Form 3160-5
(June 2019)UNITED STATES
DEPARTMENT OF THE INTERIOR
BUREAU OF LAND MANAGEMENTFORM APPROVED
OMB No. 1004-0137
Expires: October 31, 2021**SUNDRY NOTICES AND REPORTS ON WELLS**
Do not use this form for proposals to drill or to re-enter an abandoned well. Use Form 3160-3 (APD) for such proposals.

8. Well Name and No. LACEY SWISS 1 FED COM/703H

EOG respectfully requests an amendment to our approved APD for this well to reflect the following changes:

Revised Permit Information 04/26/2022:

WELL LOCATION AND ACREAGE DEDICATION PLAT

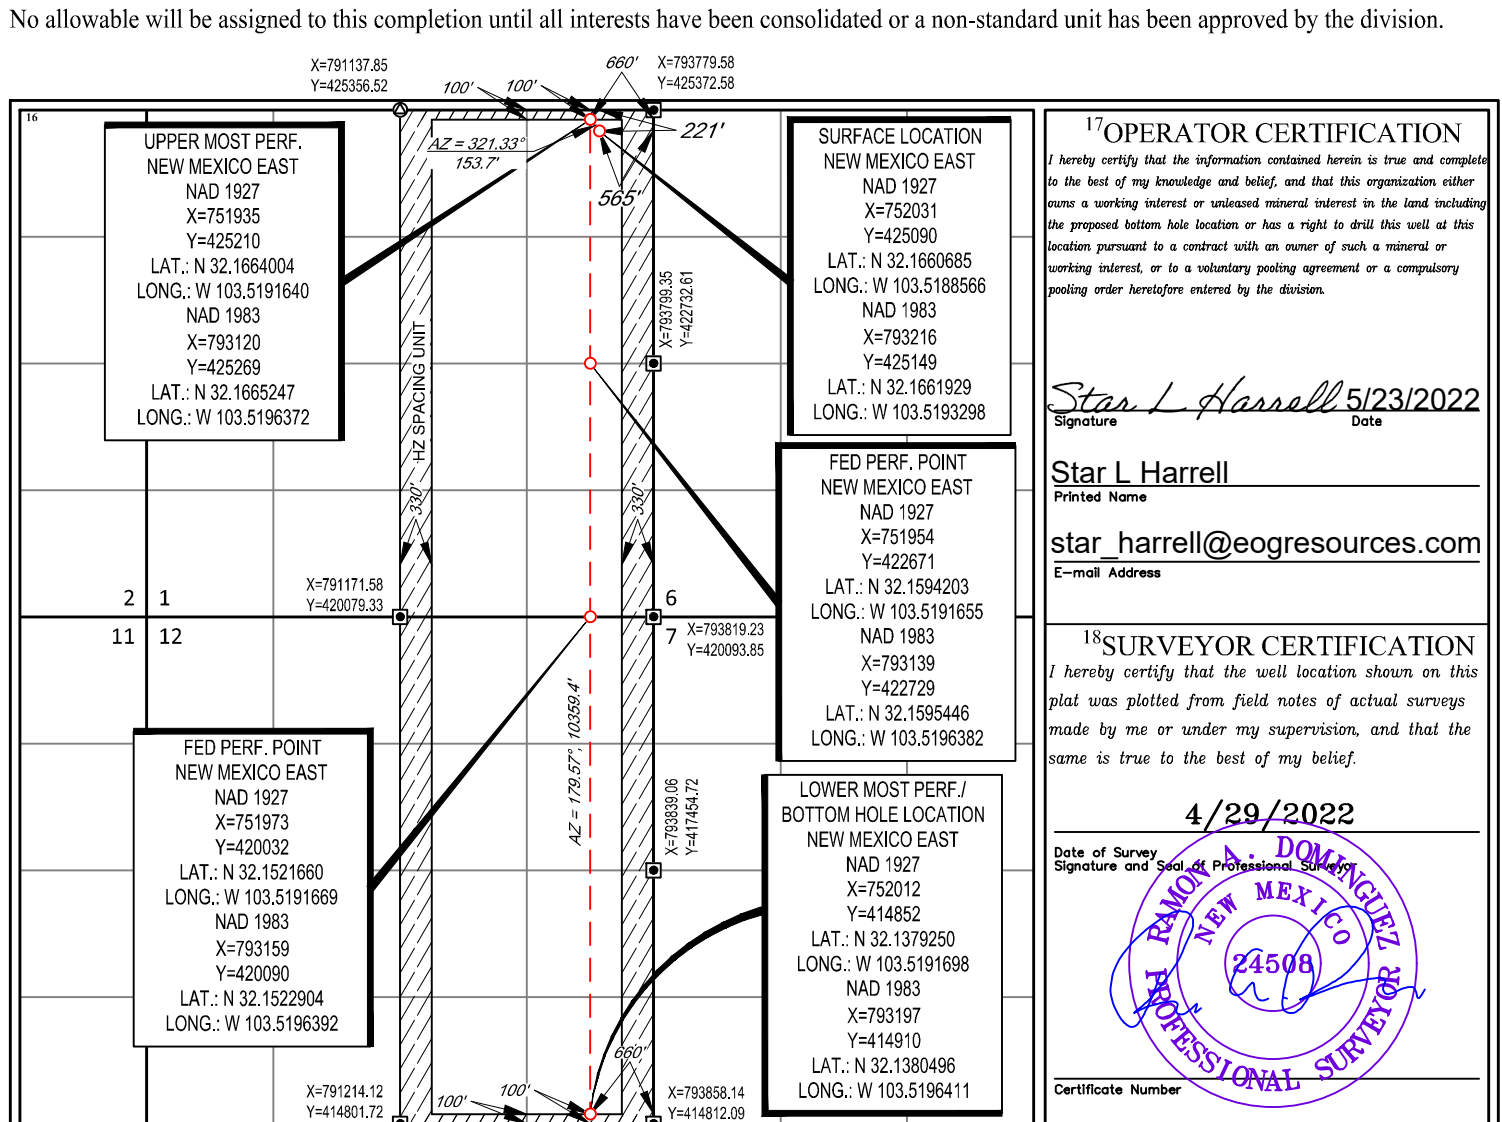
Change SHL from T-25-S, R-33-E, Sec 1, 181' FNL, 611' FEL, Lea Co., NM, to T-25-S, R-33-E, Sec 1, 221' FNL, 565' FEL, Lea Co., N.M.

Change BHL from T-25-S, R-33-E, Sec 12, 100' FSL, 1332' FEL, Lea Co., NM, to T-25-S, R-33-E, Sec 12, 100' FSL, 660' FEL, Lea Co., N.M.

UL or lot no.	Section	Township	Range	Lot Idn	Feet from the	North/South line	Feet from the	East/West line	County
1	1	25-S	33-E	-	221'	NORTH	565'	EAST	LEA

UL or lot no.	Section	Township	Range	Lot Idn	Feet from the	North/South line	Feet from the	East/West line	County
P	12	25-S	33-E	-	100'	SOUTH	660'	EAST	LEA

Revised Wellbore

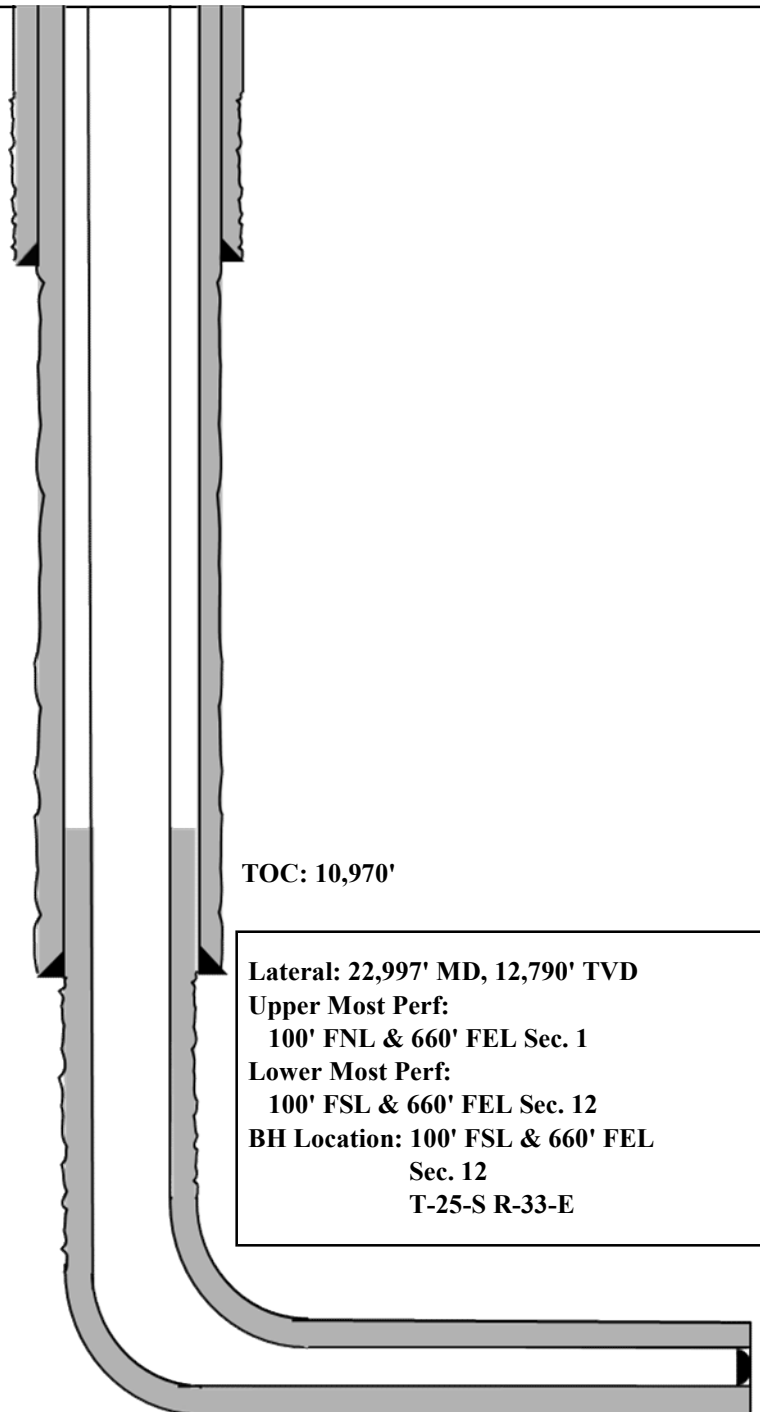
Update casing and cement program to current design.

Bit Size: 12-1/4"
9-5/8", 36#, J-55, LTC,
@ 0' - 1,300'

Bit Size: 8-3/4"
7-5/8", 29.7#, HCP-110, FXL,
@ 0' - 11,470'

Bit Size: 6-3/4"
5-1/2", 20#, P110-EC, DWC/C IS MS,
@ 0' - 10,970'
5-1/2", 20#, P110-EC, Vam Sprint SF,
@ 10,970' - 11,470'
5-1/2", 20#, P110-EC, DWC/C IS MS,
@ 11,470' - 22,997'
